**DEPARTMENT OF TRANSPORTATION  
STATE OF GEORGIA**

**FILE** P.I. # 422550-  
NH000-0006-02(055)  
Dougherty County  
GDOT District 4 - Tifton  
SR 3 @ SR 91 & N. Jefferson -  
Interchange Ramps

**SUBJECT** APPROVED REVISED CONCEPT REPORT

**DEPARTMENT OF TRANSPORTATION  
STATE OF GEORGIA  
REVISED PROJECT CONCEPT REPORT**

ALTERNATIVE NO.: **S-1**

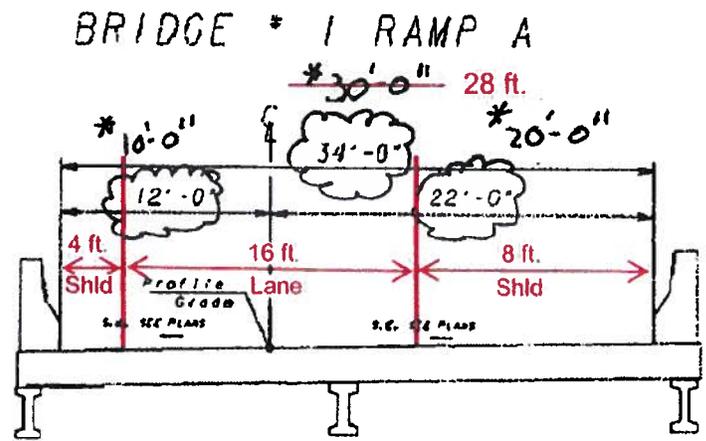
| <b>DESCRIPTION:</b> | <b>REDUCE THE RAMP A BRIDGE WIDTH FROM 34 FT. TO 30 FT.</b>   | <b>SHEET NO.: 1 of 3</b> |

The original Ramp A Bridge width is 34 ft. from gutter to gutter including a 16 ft. travel lane, 12 ft. outside shoulder, and 6 ft. inside shoulder

Reduce the bridge width to ~~30 ft.~~ **28 ft.** from gutter to gutter including a 16 ft. travel lane, ~~10 ft.~~ **8 ft.** outside shoulder, and 4 ft. inside shoulder

Reducing the bridge width by 4 ft. allows it to match the paved shoulder sections and reduces associated labor and material requirements.

\* Reduced shoulder width by 2'-0" on each side.

The bridge on Ramp A will carry a 16-ft travel lane, 4-ft paved inside shoulder, and 8-ft paved outside shoulder, for a total "gutter to gutter" bridge width of 28-ft. This width is 2-ft less than the VE study recommended. Based on the VE study calculations, a bridge width of 28-ft would result in a cost savings of approximately \$116,000 compared to the VE recommendation of 30-ft which showed a cost savings of approximately \$71,000.

ALTERNATIVE NO.:  
**S-2**

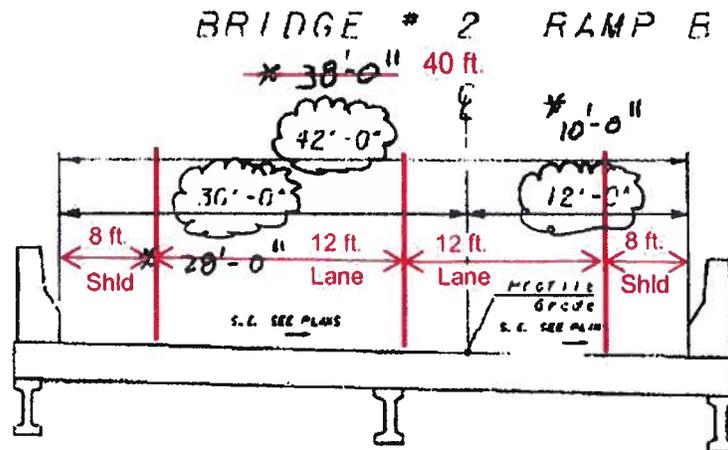
**DESCRIPTION:** REDUCE THE RAMP B BRIDGE WIDTH FROM 42 FT. TO 38 FT.

The original Ramp B Bridge width is 42 ft. from gutter to gutter which includes two, 12 ft. through lanes, a 12 ft. outside shoulder, and a 6 ft. inside shoulder.

Reduce the bridge width to ~~38~~ <sup>40</sup> ft. from gutter to gutter including two 12 ft. through lanes, a ~~10~~ <sup>8</sup> ft. outside shoulder, and a ~~4~~ <sup>8</sup> ft. inside shoulder.

Reducing the bridge width by 4 ft. allows it to match up with the paved sections and reduces associated labor and material requirements.

\* Reduce shoulder width by 2'-0" on each side.

The bridge on Ramp B will carry two 12-ft travel lanes, an 8-ft paved inside shoulder, and an 8-ft paved outside shoulder, for a total "gutter to gutter" bridge width of 40-ft. The resulting width is two feet greater than the VE study recommendation. The inside paved shoulder near Ramp B is 8-ft wide to accommodate a concrete barrier on top of a fill wall that will tie to the bridge barrier. The inside shoulder on the ramp bridge is 8-ft wide so the bridge barrier will align with concrete barrier on top of the wall without having to taper as it approaches the bridge. Based on the VE study calculations, a bridge width of 40-ft would result in a cost savings of approximately \$65,000, compared to the VE recommendation of 38-ft, which showed a cost savings of approximately \$130,000. The result of revising the implementation of Alternatives S-1 and S-2 is a total cost savings of \$181,000, compared to the VE cost savings of \$201,000.

TYPICAL SECTION NO. -5 A  
 TANGENT SECTION  
 APPLIES TO STA. 214+40.00 TO STA. 216+18.00

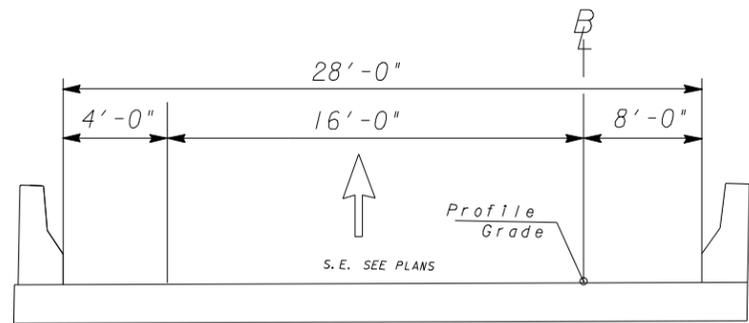
Alternatives S-1 and S-2 recommend reducing the bridge widths on Ramp A (from 34-ft to 30-ft) and Ramp B (from 42-ft to 38-ft) by narrowing the shoulders 2-ft on each side. The VE implementation letter states that these alternatives will be implemented; this office requests to revise the implementation of these alternatives. Recent discussions between Roadway Design and Bridge Design have led to a decision that the bridges should carry the full width of the ramp lane plus the width of the paved shoulders (guidance in AASHTO 2004 Green Book, pg. 506). Applying this guidance results in bridge widths of 28-ft and 40-ft for Ramps A and B respectively.
